Access Compliance Report

Public Rights-of-Way (Curb Ramps)

| Intersection ID: 29915 | Main Street: NORTHRIDGE_DR | Cross Street: WYNDHAM_HILL_DR | Location: SW |
| ADA ID: 9A697ECC975C | Ramp Type: PerpDiag | Initial Pass/Fail: Fail | Overall Compliance: No Severity Score: 21.25 |

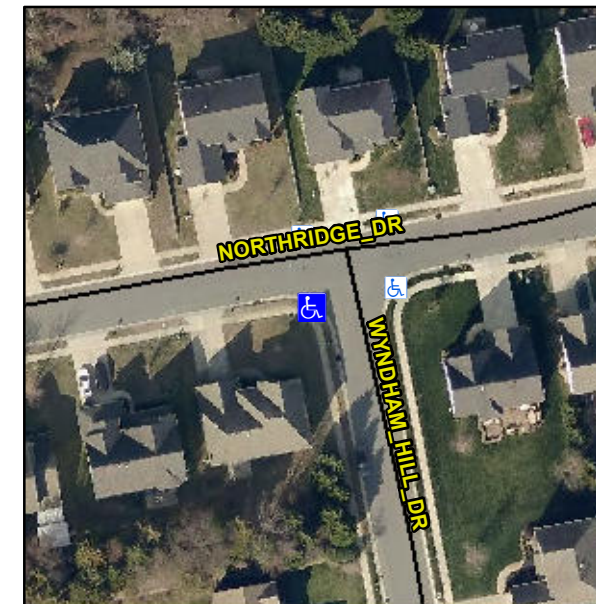
R304.5.1, R304.5.3

| Compliance | Description | Data | Compliance | Description | Data |
|------------|-----------------------|------|------------|-----------------------------|------|
| No | Ramp Width (in) | 40.0 | No | Ramp XSlope (%) | 6.6 |

Remove & Replace Curb Ramp With Two New Directional Ramps or Equivalent.
